From: Lisa Moore [REDACTED]
Sent: Monday, July 17, 2023 12:58 PM
To: Elissa Commings
Subject: Channel Drive

Subject: Channel Drive

From: er@themandalaygroup.com <er@themandalaygroup.com>
Sent: Friday, January 5, 2024 9:55 AM
To: Elissa Commins <ecommins@twp.brick.nj.us>
Cc: lisa moore [REDACTED]
Subject: #23026 / Shore Acres Club / Bulkhead Replacement Project /

PRELIMINARY MAP OF PROPOSED SUBDIVISION FOR JOE PAL INC.

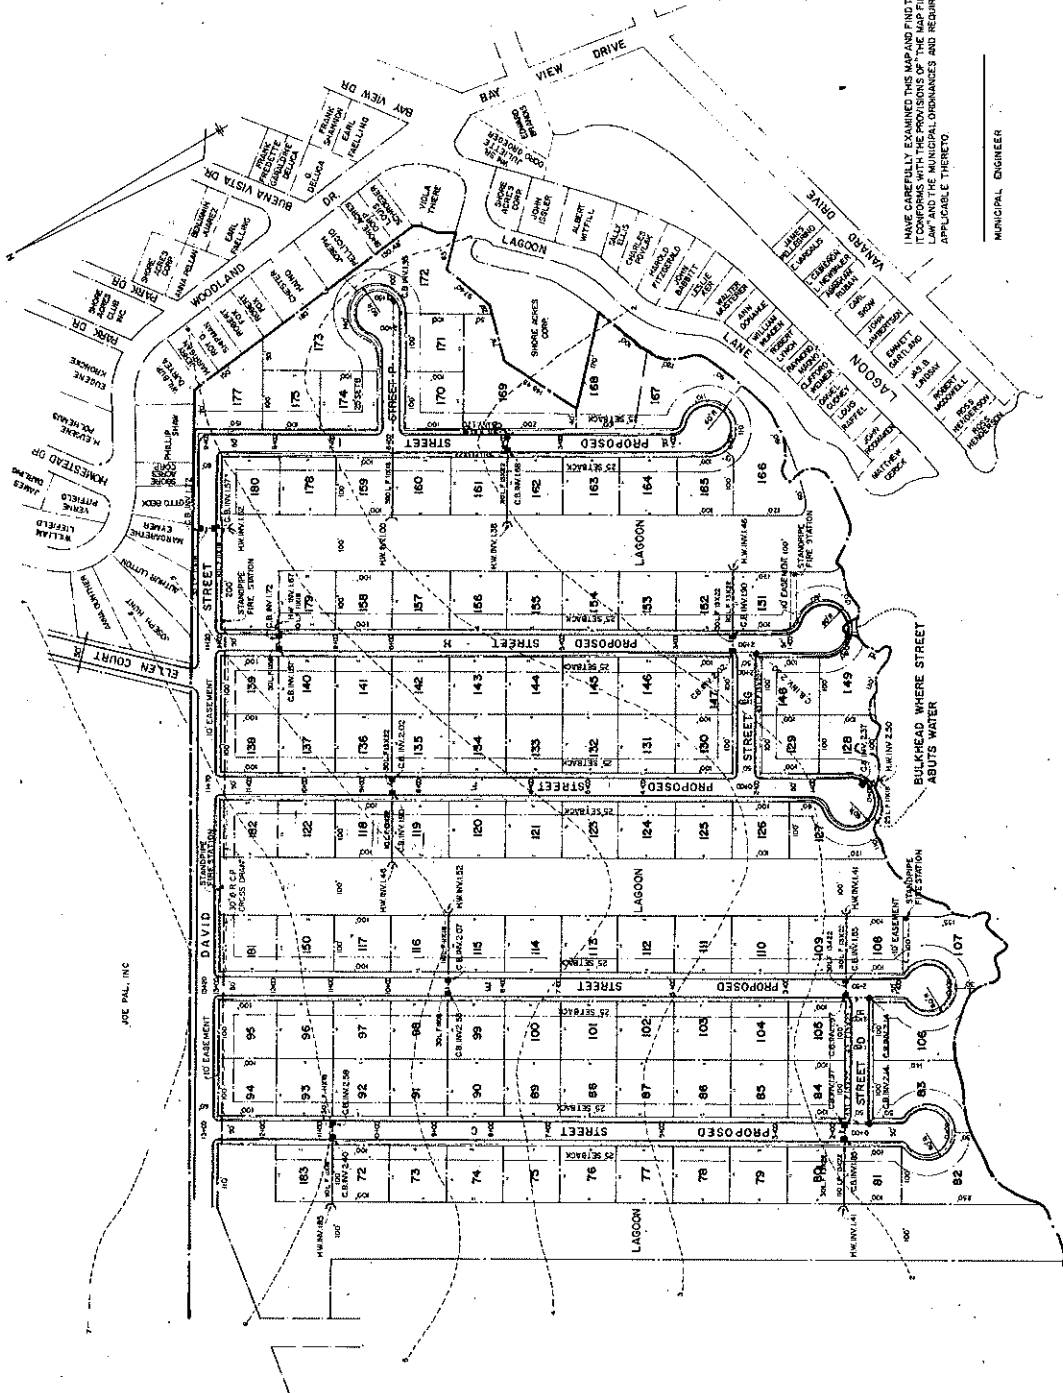
I found the original filed map from Shore Acres. It is attached for reference. The map has Channel Drive listed as Lagoon Drive, but it does have a 4-foot wide reserve strip in between the road and the water. I imagine it was either for exactly what you have been using it for, docking, or it was a "Spite-Strip", which was more common than you would think in the 1940's-1960's. It was a small strip of land to prevent adjacent communities from using one another's amenities, like roads, clubhouses, etc.
